IEEE 802.3cg

False Carrier Indication in 10BASE-T1S

July 15th, 2019

Figure 147-7—PCS Receive state diagram (part a)

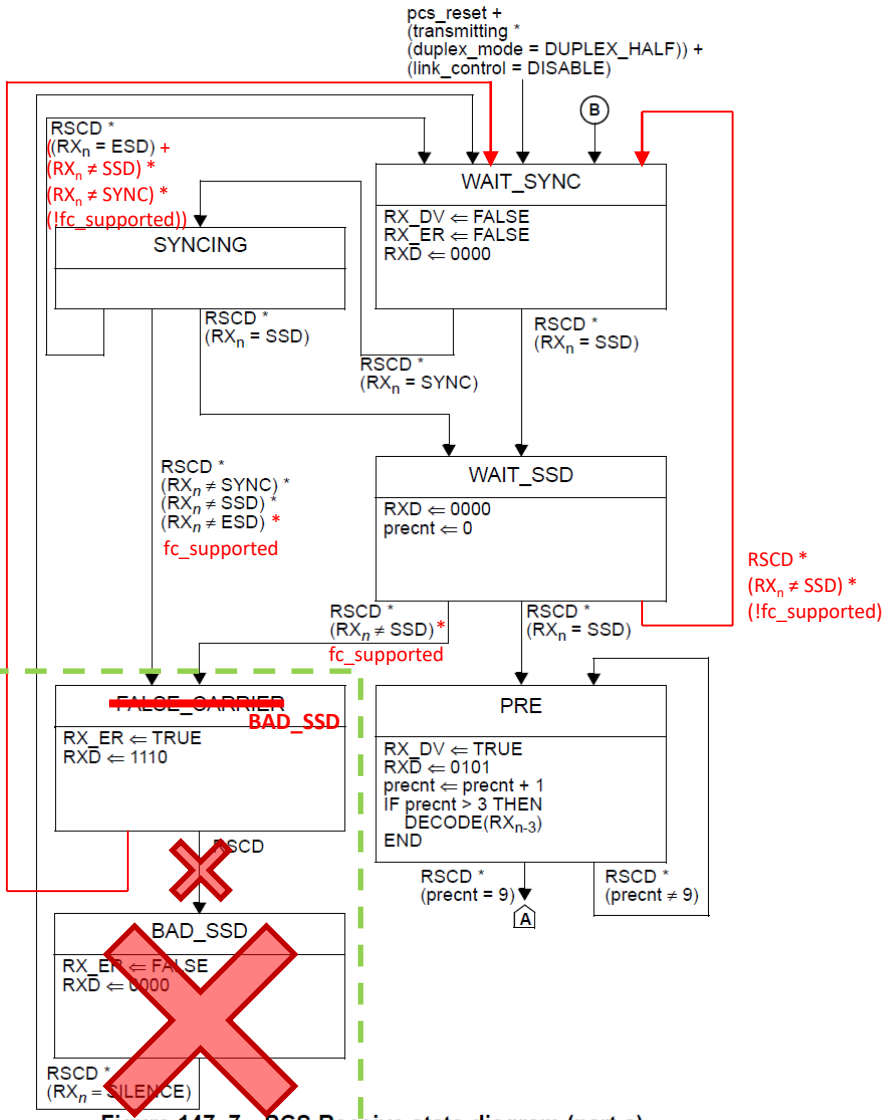
- The False Carrier indication seems to be only relevant to repeaters and 100BASE-X
 - Clause 27 is the only one specifying a consequent action for a FC
 - It is not specified for any existing 10 Mb/s PHY using the MII
- 10BASE-T1S/L does not specify support for repeaters
 - **9.1 Overview**
This clause specifies a repeater for use with IEEE 802.3 10 Mb/s baseband networks, **with the exceptions of 10BASE-T1L (Clause) and 10BASE-T1S (Clause 147)**. A repeater for any other IEEE 802.3 network type is beyond the scope of this clause.
- It is ignored by the MAC and it is optional in Clause 22.
- **It creates additional complexity in T1S but it might worth keeping for future-proofing**

- **Suggest to make FC handling optional in 802.3cg for 10BASE-T1S**

Also align FC indication behavior to 100BASE-X and 10BASE-T1L: FC should persist until TX is over

Apply modification in red to Figure 147-7

Change content of “147.3.3.3 Constants” to: “

fc_supported

Indicates whether the optional False Carrier detection is supported.

Values: TRUE or FALSE

Add the following to 147.12.4.2 PCS Receive:

Item	Feature	Subclause	Value/Comment	Status	Support
PCSR8	False Carrier supported	147.3.3.x	See Figure 147-7	O	Yes []
